CUSTOMER TECHNICAL MEMO # 273

Subject HD28 HD Deep Interlock Date: October 2016

Code	Description	Mass	AP	PP
1410228	HD28 HD Deep Interlock	0.323	100	100

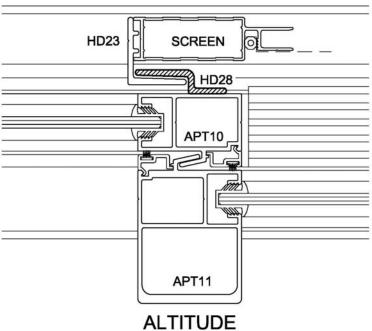
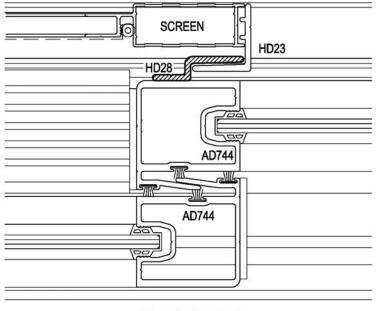
We have developed a new heavy duty deep offset interlock to improve engagement with HD23.

With the increased offset there is now greater clearance on engagement and better alignment of HD23 on the screen suitable for ProGlide and Altitude.
